Design Problem No. 1

Dean L. Sicking, Ph.D., P.E.
2004 Roadside Safety Workshop
June 23-24, 2004

Design Problem No. 1

Plan view of pond, culvert, and cable barrier

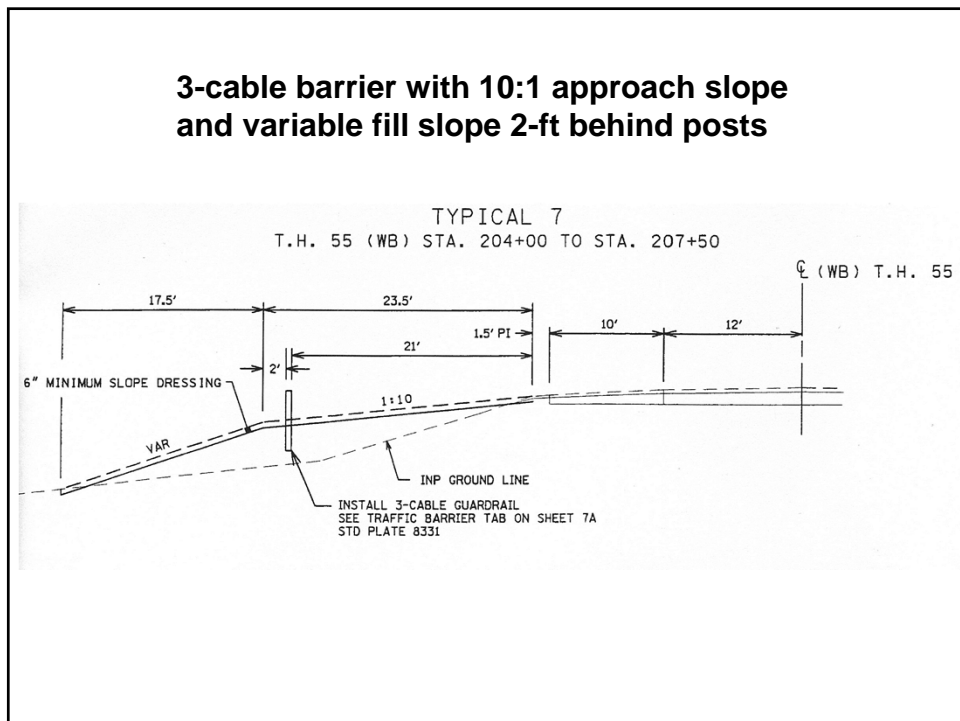
- three cable barrier incapable of redirecting 2000P vehicle impacting at TL-3 condition of NCHRP 350 when installed adjacent to 1.5:1 slope
- TL-3 approved, strong-post, W-beam design variations exist when placed near or directly on 2:1 fill slope

- could conduct benefit-cost analysis to determine whether entire hazard required protection
- extending protection to include entire hazard is reasonable and appropriate due to small increase in guardrail length
- if MnDOT treats hazards entirely outside of clear zone, agency wide policy should be adopted
- potential tort risk associated with inconsistent application of clear zone principles

- Cable guardrail may function in this application, but research not yet complete
- Simulation study indicates cable barrier should provide acceptable performance when placed 3' in front of slope break point and post spacing reduced to 4'
- W-beam guardrail with 7' posts on 3'-1.5" centers placed at the slope break point is an NCHRP Report 350 approved alternative
